DCS MS-016

Docket Nos. 50-335
and 50-389

Enclosure:
 Corrected page 6-3 to
 Amendment No. 62 to
 DPR-67

ST. LUCIE - UNIT 1

Figure 6.2-2 Unit Organization - St. Lucie Plant, Unit 1

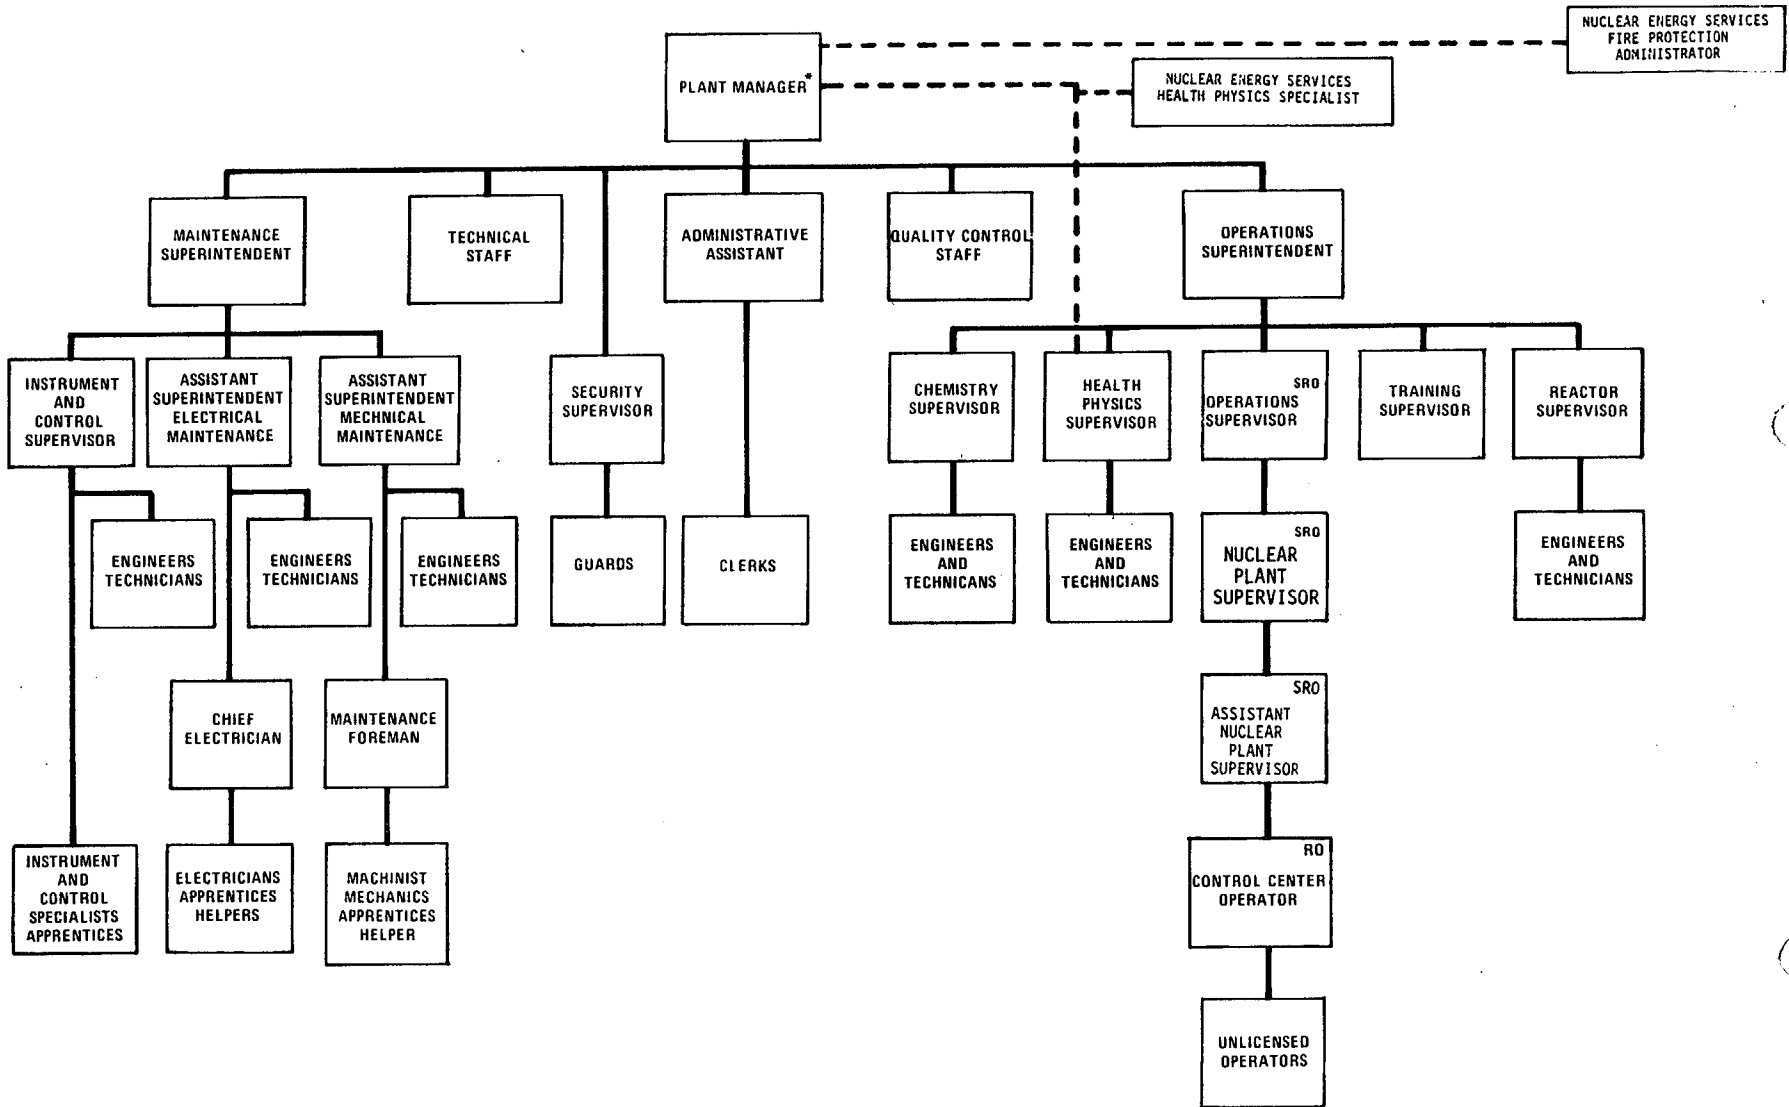
On Figure 6.2-2 attached to Amendment No. 62 for St. Lucie 1, the old amendment number was inadvertently left on as a valid number and the new number was not added as is customary. The figure was otherwise correct as issued.

Enclosed is a copy of page 6-3 (with overleaf page) showing the correct amendment number. Please accept our apologies for any inconvenience this administrative error may have caused.
